April 26, 2024
PROJECT NAME: DIMOVSKI PROPERTIES BRANKO DUPLEXES
PROJECT NUMBER: 2024040066
APPLICATION: DRC WAIVER REQUEST #31437

DEVELOPMENT REVIEW COMMITTEE WAIVER REQUEST FORM

LANDSCAPE PLAN
PREPARED FOR: BRANKO DUPLEX
45 JUNIPER PASS – TAX PARCEL NUMBER 9025–0639–01
OCALA, FLORIDA

SHEET
LA–001

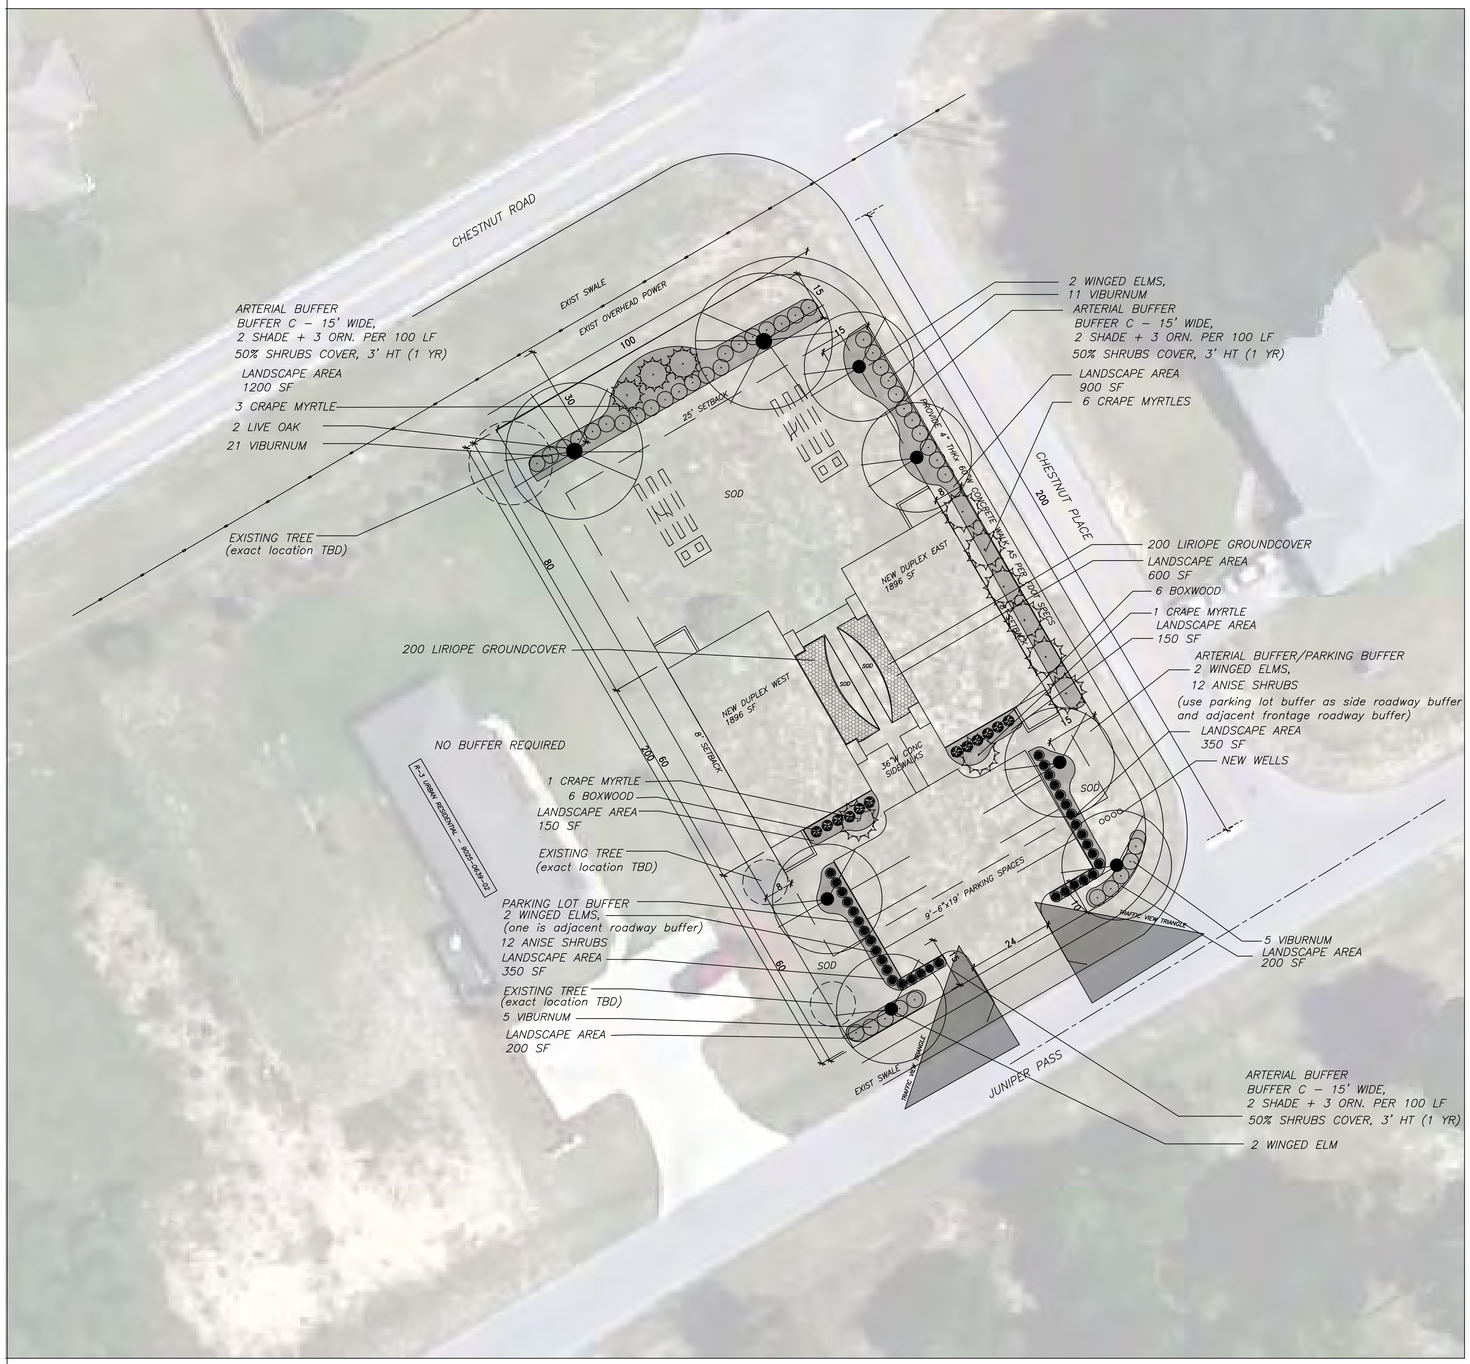
2 DEPARTMENT: ZONE - ZONING DEPARTMENT
REVIEW ITEM: LDC 6.8.6.K(3) - Buffers
STATUS OF REVIEW: INFO
REMARKS: Staff is supportive of the C type buffer reduction from 15' to 8' ft; standard buffer planting requirements will still apply if approved.

4 DEPARTMENT: LSCAPE - LANDSCAPE DESIGN AND IRRIGATION
REVIEW ITEM: LDC 6.8.6.K(3) - Buffers
STATUS OF REVIEW: INFO
REMARKS: staff supports

D. WAIVER INFORMATION:
Section & Title of Code: 6.8.6.K (3)
Reason/Justification for Waiver Request: REDUCE ARTERIAL BUFFER TYPE C ALONG CHESTNUT PLACE FROM 15 FT TO 8 FT TO FIT IN THE BUILDING SETBACK. THE REMAINDER OF THE BUFFER WILL BE 15 FT USING SOME COMBINATIONS OF BUFFERS REQUIRED.
